Technical Service Bulletin

Cobra Motorcycle Mfg.

TSB0510 2010 King Chain Guard Fastener

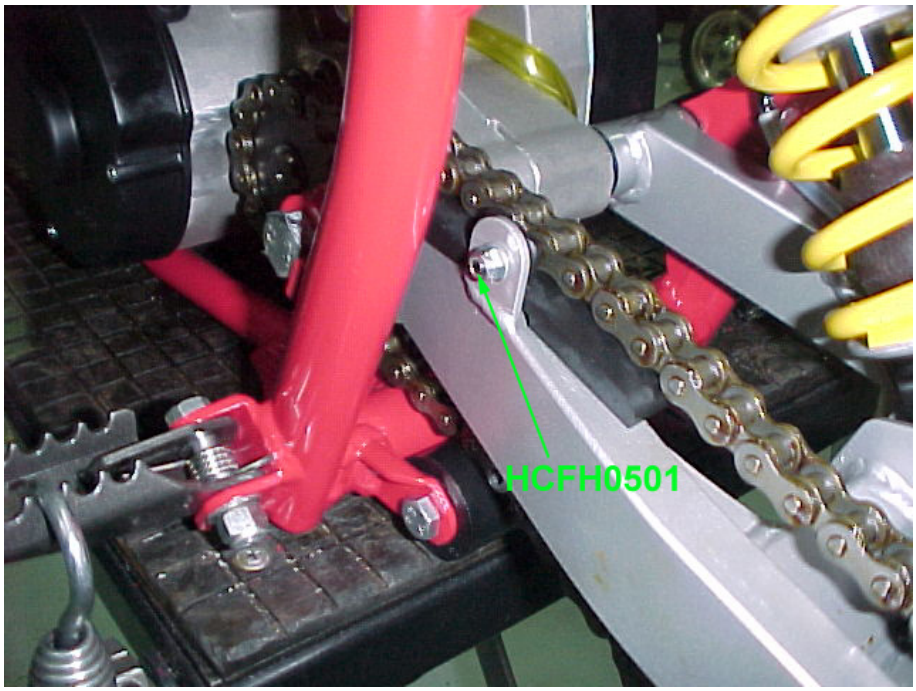
Early 2010 King production models were built with a chain guard fastener (flat head M5 x 16) that was too long and could cause contact with the frame upon full suspension collapse. The new shorter fastener used in production is M5 x 12 flat head HCFH0501.
